DEPARTMENT OF T	TE INTERIOR SURFILL OF Land Mana	aglament
BUREAU OF LAND M	${f IANAGEMENT}$ Farmington Field (ic5: Lease Designation and Serial No. Contract 55-A
SUNDRY NOTICES AND REPORTS ON WELLS		6. If Indian, Allottee or Tribe Name
Do not use this form for proposals to drill or to de Use "APPLICATION FOR PERM	epen or reentry to a different reservoir.	Jicarilla Apache

PLUG & ABANDONMENT PROCEDURE

Chacon Jicarilla Apache D #110 Chacon Dakota Associated

Re: Permanent Abandonment Well: 110 Chacon Jicarilla Apache D

Chacon Jicarilla Apache D #110 Proposed P&A

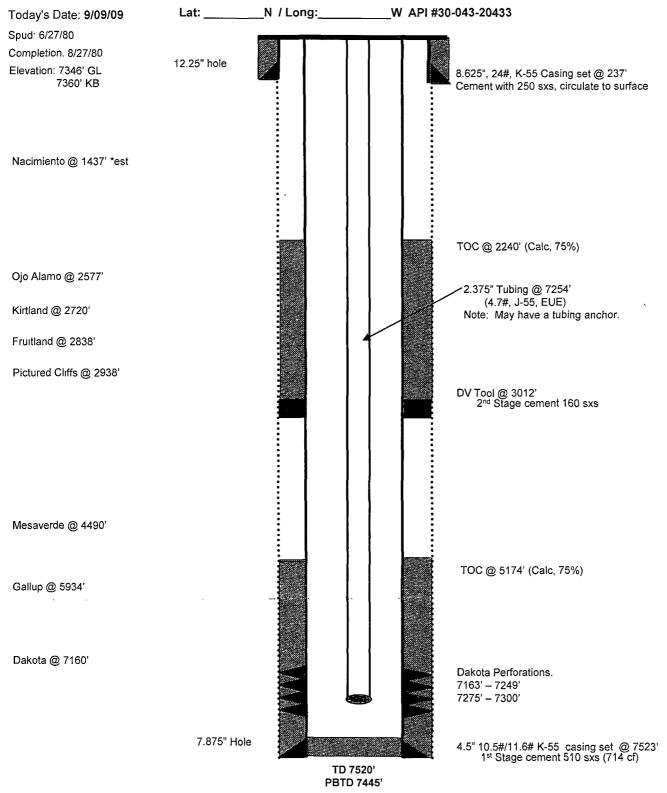
- 1. Plugging operations authorized are subject to the attached "General Requirements for Permanent Abandonment of Wells on Federal and Indian Lease."
- 2. Farmington Office is to be notified at least 24 hours before the plugging operations commence (505) 599-8907.
- 3. The following modifications to your plugging program are to be made:
- a) Place the Gallup plug from 6076' 5976'.
- b) Place the Nacimiento plug from 1380' 1280' inside and outside the 2 7/8" casing.

You are also required to place cement excesses per 4.2 and 4.4 of the attached General Requirements.
